PRODUCT CHANGE NOTIFICATION

REVISED JULY 14, 2023

Bourns® Model PEC11S Series 12 mm SMD Incremental Encoders

Packaging Improvement – Tray Type and Carton Size

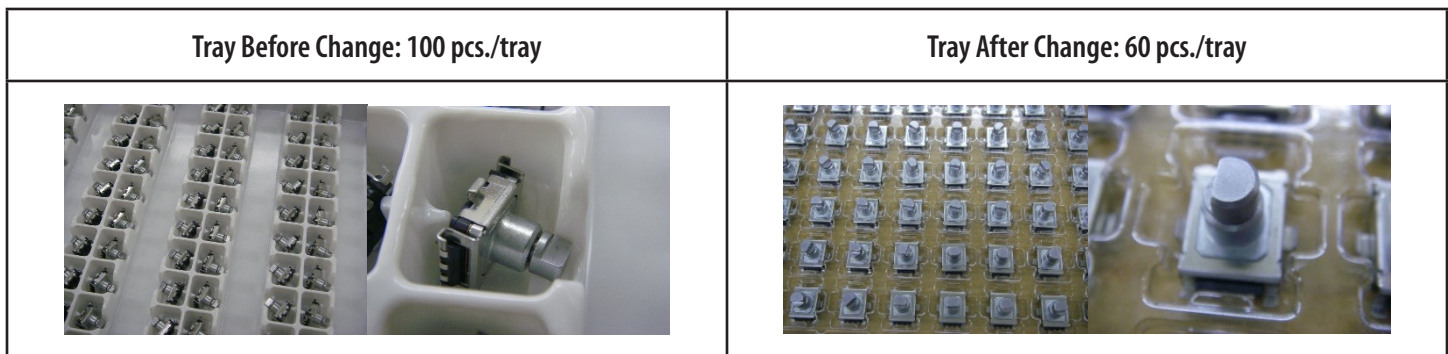
Riverside California – December 1, 2022 – In the spirit of continuous improvement, effective January 1, 2023, Bourns will change the tray type and carton size of the [Model PEC11S Series 12 mm SMD Incremental Encoders](#). The quantity of the parts in each tray will be reduced and the size of the carton boxes will be reduced as well. However, the smaller tray size will allow more trays to fit in each carton box. As a result, minimum order quantities (MOQs) and multiples (Mults) will be affected as displayed in the table below. A complete list of affected part numbers is also provided below.

There is no change to the form, fit, or function of the actual product as this is a packaging change only. Quality and reliability should be improved due to the reduction in air contact and movement of the product within the tray. There is no change to packaging quantities.
